**Town of Hinesburg
Planning Commission
January 23, 2019
Approved February 13, 2019**

Official Map Revisions:

DRAFT 6
(for PC review)

Official Map - Community Facility Descriptions

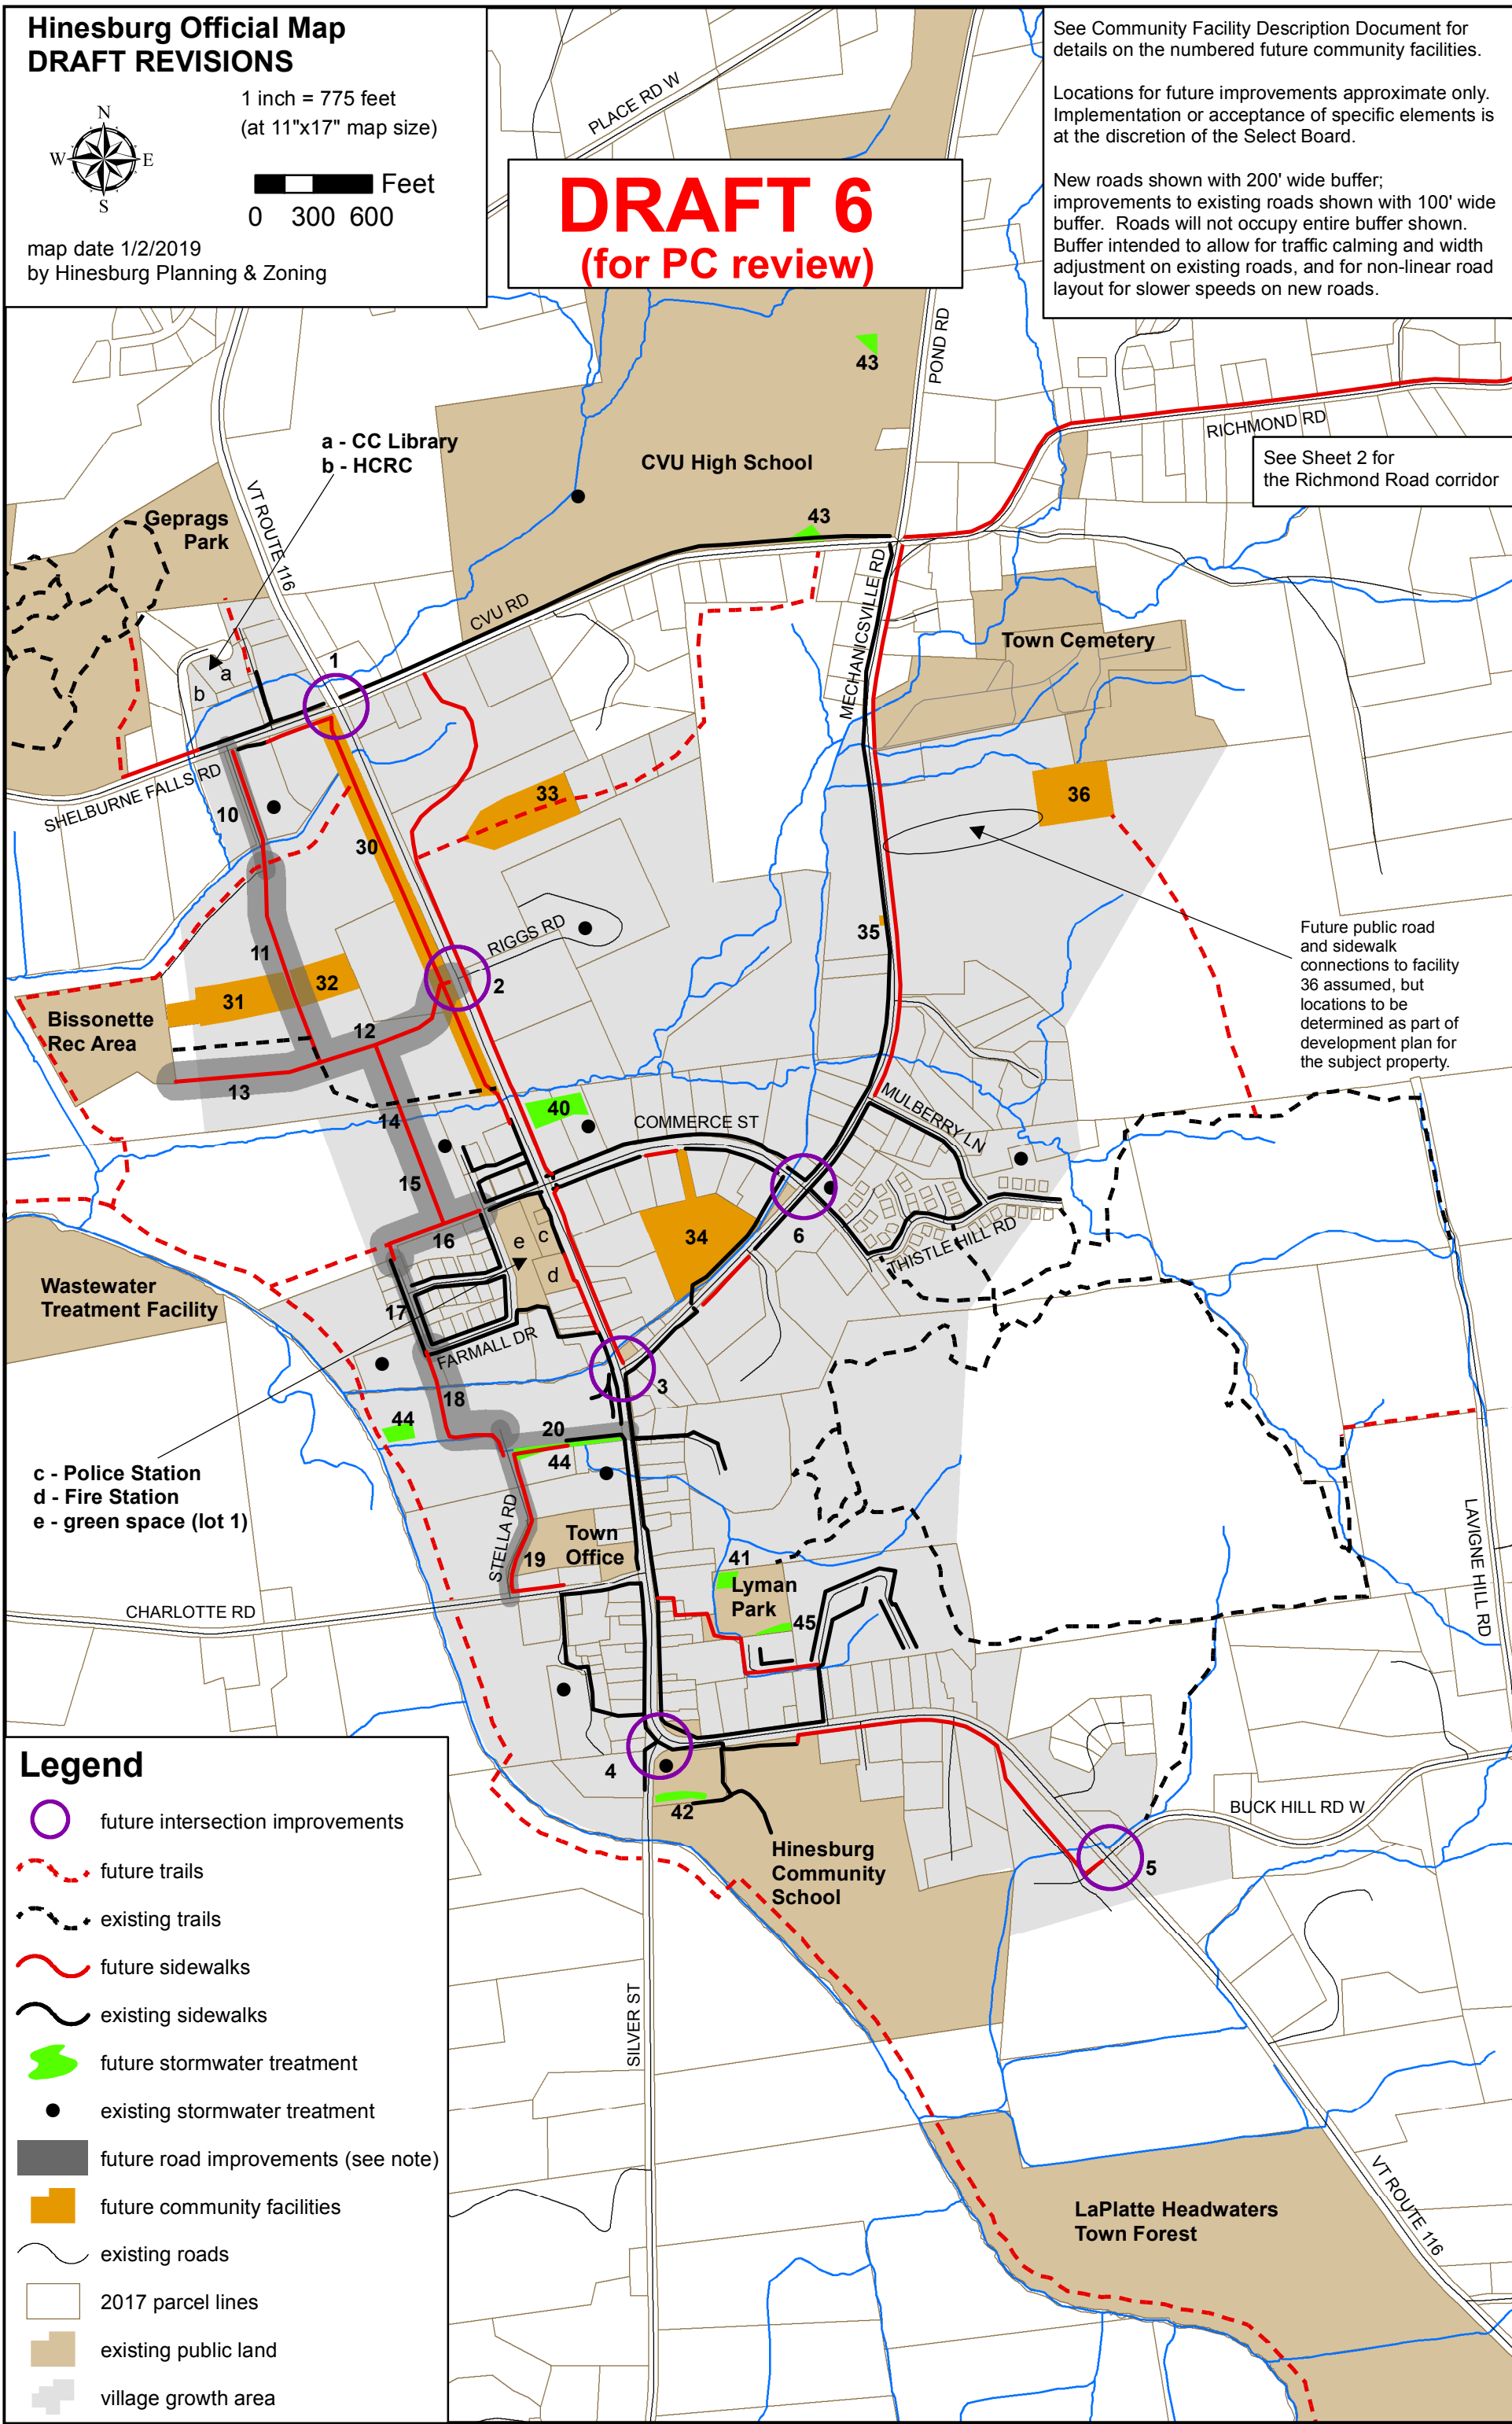
Maggie G. mentioned that Alex has included along with draft 6 the expanded map going up to North Rd. and Richmond Rd. Alex W. walked through the changes leading up to draft 6. Draft 5 was the beginning of the public input period. Since then, he has reincluded the connection to Geprag's from Ballard's Corner. Lenore Budd (Trails) would like to see the dotted line from behind Ballard's continue into the park; the Commission agreed this would be fine.

John K. wanted the connection of proposed road from south, north to Shelburne Falls Rd. to be extended; Alex W. did this and narrowed the buffer here. The numbering/labeling system has changed, and corresponds to the narrative document. On the west side of 116, Alex W. labeled the police station, fire station, and green space (lot 1). He also labeled the library and Hinesburg Community Resource Center. The Commission had discussed moving stormwater treatment from behind Hart and Mead to the NW corner of Lyman Park. Alex W. spoke with the school (both Hinesburg and CVSD), and all thought it was fine as long as it didn't impact the softball outfield. Joe I. asked if the school had an agreement with the state that would require green space here. Alex W. replied they didn't comment on this.

John K. asked about the two number 44's (see attached Facility Descriptions). Alex W. replied that the town discovered it wasn't possible to do stormwater treatment within the stream. The western part of 44 is higher elevation and would need to have water pumped up into it. Alex W. replied perhaps something could happen south of number 18; he and Andrea M. had investigated this in the past, and it has significant wetlands and is in the flood hazard area. The granting agency didn't like wetland impacts and that it was in the flood hazard area. But, the state wouldn't necessarily have a problem with doing treatment here, this restriction was just due to the granting agency. Alex W. suggested adding a new number, and shifting the in-stream system to something to the west.

Joe I. asked about number 35. Did they decide to put on west or east side of road? Alex W. noted they added sidewalk on east side of road. Maggie G. said she wouldn't want to remove it. Most agreed.

Alex W. also spoke with CVU about #43 on their properties; they haven't done anything on those specific locations, and he assumes that there is no problem with this. John K. requested putting more dots on the CVU map with existing stormwater treatment areas.

Alex W. stepped out, and the Commission examined the facility descriptions. Jeff F. brought up 10 and 11 near Rec Area; is this a temporary road that needs to be identified on here? Most agreed this would be a good idea.

John K. brought up 14 and 15 (Patrick Brook Crossing) and 18 (Canal Crossing): wouldn't this require permitting, and is this an issue? Alex W. said yes, it will be difficult and expensive to go over Patrick Brook and the Canal. John K. would recommend mentioning this.

Dennis P. asked about the culvert under 116; Alex W. stated that Lewis Creek Association and the experts they've hired recommend that it be made larger. VTrans said it's close to proper size and in pretty good shape, so it will wait unless there's a maintenance issue. Alex W. will add additional language to numbers 14 and 18. Alex W. mentioned that when Brett Grabowski proposed phase 2, The Board asked Brett Grabowski (at 14) and his hydrogeologist to model the crossing here, with the appropriate size box culvert and looked at impacts to flood elevations. They concluded that this area (14) will only require a large box culvert.

Jeff Glassberg: on number 33, Jeff G. requested a boundary revision to hug the trail. Because Jan has preserved 3 lots back behind, and given town a conservation easement, does it make sense to extend park back to include those three lots? Jeff F. mentioned it is a nice view. The Commission liked the idea.

Sheet 2 - DRAFT 6
(for PC review)

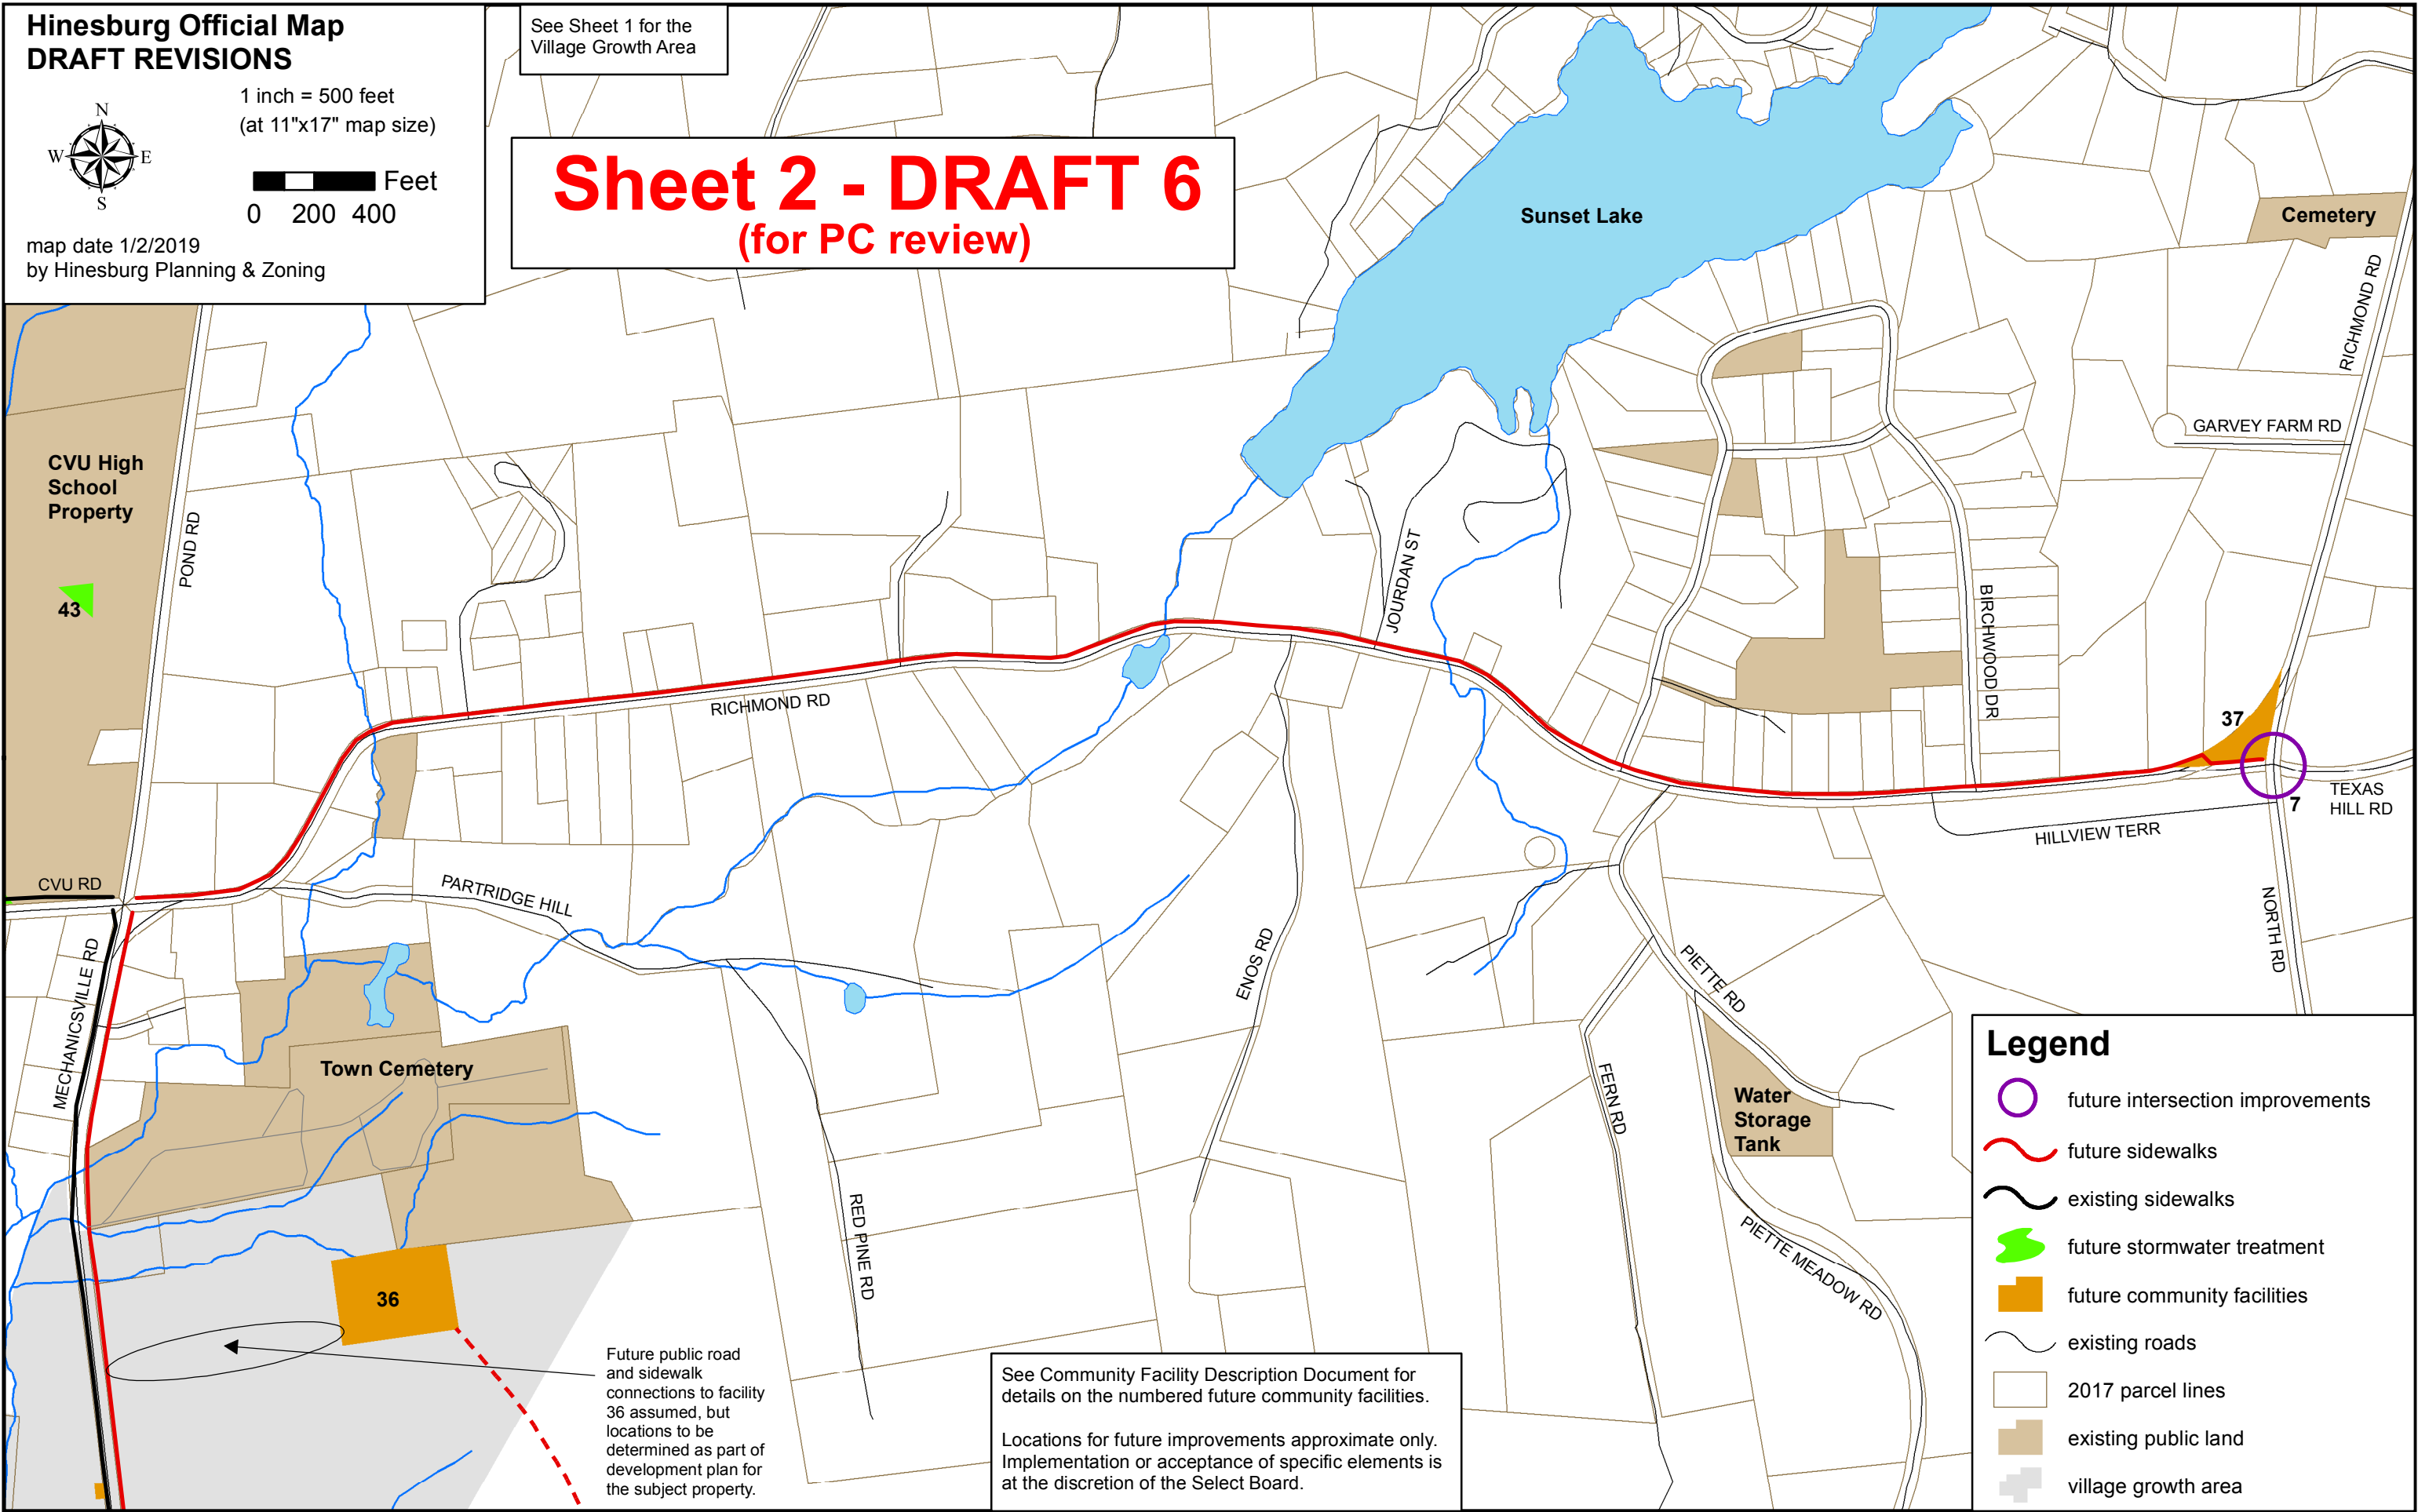
Maggie G. suggested going to sheet 2. Alex W. mentioned that the Selectboard wants to move forward with a sidewalk along Richmond Rd., and they are looking at options (path, etc.). Alex W. was instructed to apply for a Chittenden County Regional Planning Commission grant to study the Richmond Rd/North Rd. intersection. Maggie G. said it would slow down Richmond Rd. traffic and potentially provide a skate park for kids who are skateboarding on North Rd. She pointed out that power trucks use it as a staging area, and Joe I. mentioned the reverse park n ride that we heard about through public comment.

Alex W. asked if the Commission wanted this sheet at all. He pointed out other publicly owned parcels in the Birchwood Drive area. Marie G. said they were given to the town over the years by Ernie Giroux; this happened when the town accepted things regardless of resources or value. Marie G. felt the slivers to the north aren't of any use. The forested one may be of use; kids use it to play in. Alex W. displayed the area (which has a wetland constraint), which still has 180 feet wide unconstrained. It is much more sizable than the intersection area. Dennis P. suggested moving the park over to Birchwood, which would also save sidewalk.

Maggie G. asked if it would be necessary to show a future community facility here, because the town already owns it. Alex W. said it seems like a good location, but we haven't talked to any of the neighbors. Dennis P. suggested selling the other three town-owned lots in Birchwood, and put the money toward a park.

Marie G. felt we should know more about it before we put it on the map. John K. agreed, and said we should have a site visit. The Commission agreed to wait to do a site visit, and Alex W. will speak with the neighborhood.
